Product Change Notification (PCN)

PCN #: 10C-2024

Date: October 9th, 2024

5.1 Product (Antenna Silkscreen)

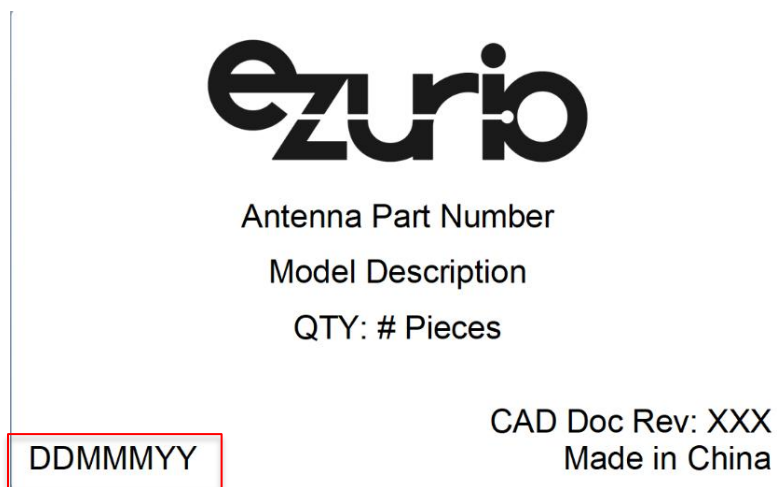
- Revision can be found on the antenna silkscreen. Only major revisions are printed. Logo change from Laird to Ezurio is a sign of the change.
